Work Order ID 53793

Item Name: Basket Hoop

DRAWING NO. D3166	TITLE BASKET HOOP	REV A1	DART AEROSPACE LTD ENGINEERING ORDER		D.E.O. NO. D3166-A-2	SHEET NO. 1 OF 1	SCALE NTS
DRAWN AJS	CHECKED <i>[Signature]</i>	MFG. APPR. <i>[Signature]</i>	APPROVED <i>[Signature]</i>		DE APPR. <i>[Signature]</i>		
DATE 08.12.11	DATE 08.12.15	DATE 08/12/15	DATE 08/12/16		DATE 08.12.16

DESIGN #	DRAWN BY CP	DART AEROSPACE LTD HAWKESBURY, ONTARIO, CANADA	
CHECKED #	APPROVED #	DRAWING NO. D3166	REV. A SHEET 1 OF 1
DATE 02.07.10		TITLE BASKET HOOP	SCALE NTS
A	02.07.10	NEW ISSUE	
A1	04.04.08	38 +/- 1 mm 36.0

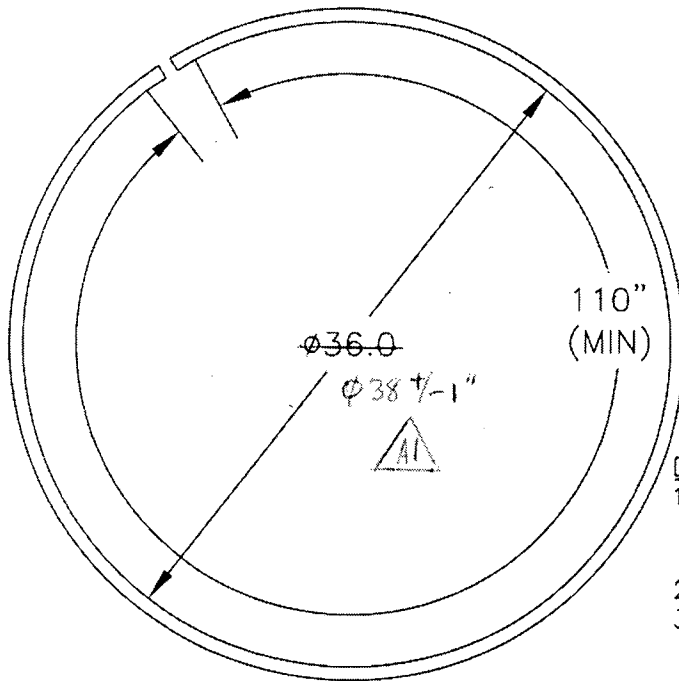
1) MODIFY MATERIAL NOTE FOR D3166-1 AS SHOWN:

WAS:

1) MATERIAL: AISI 304/316 SS SQUARE TUBING,
0.75" x 0.75" x 0.063 WALL, 60.00" LONG
(REF DART SPEC. M304TS0.750W.063)

2) MODIFY MATERIAL NOTE FOR D3166-3 AS SHOWN:

WAS:

1) MATERIAL: AISI 304/316 SS SQUARE TUBING,
0.75" x 0.75" x 0.063 WALL, 120.00" LONG
(REF DART SPEC. M304TS0.750W.063)

REASON: SEE PAR 08-005

IS:

1) MATERIAL: AISI 304/316 SS, 3/4 X 3/4 X 0.065 WALL SQUARE TUBING,
60.00" LONG
REF. DART SPEC M304TS0.750W.065

IS:

1) MATERIAL: AISI 304/316 SS, 3/4 X 3/4 X 0.065 WALL SQUARE TUBING,
120.00" LONG
REF. DART SPEC M304TS0.750W.065
